ADDENDUM NUMBER ONE
RFQ # 7467368

TITLE: Purchase and Install Generator and Transfer Switch-Warwick Armory

STANDARD DETAILS & SPECIFICATIONS

SUBJECT: Specifications for the installation of bollards for private fire protection equipment, generators, and fuel tanks

BOLLARD DETAIL

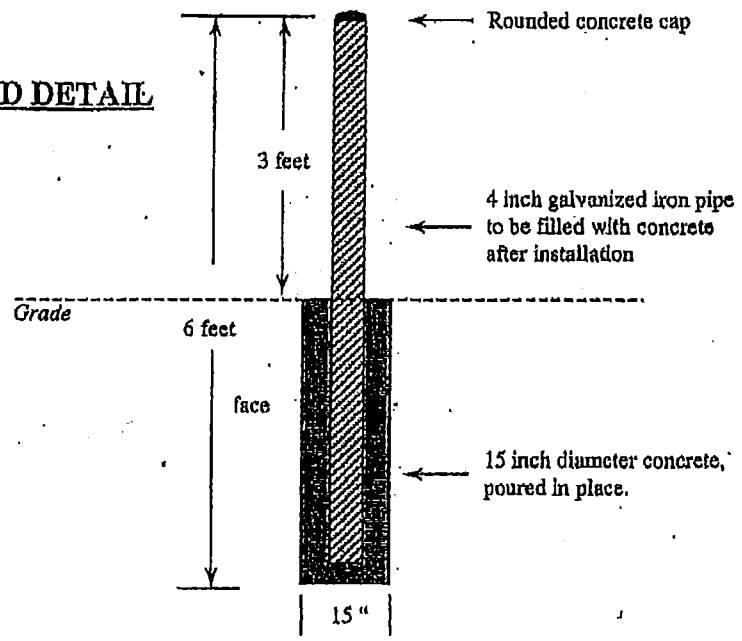
Attached is bollard specification. Total of four (4) bollards will be required.

3000 PSI concrete will be used; bollards will be covered with safety yellow bollard sleeves. Due to location restrains on-site modification to specifications can be authorized by the construction supervisor

HYDRANT POST LOCATIONS

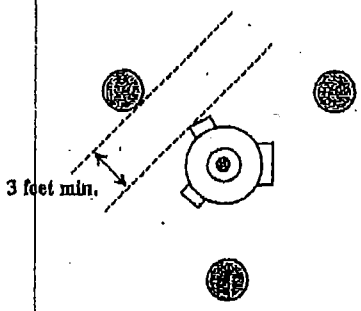
Bollards shall be three (3) feet minimum from the face of fire hydrant. All orifices shall be unobstructed.

GENERATOR/FUEL TANK POST LOCATIONS

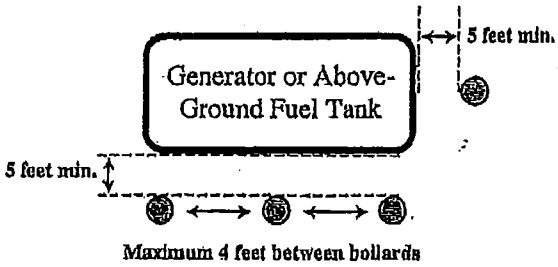
Bollards shall be five (5) feet minimum from the face of fire hydrant.
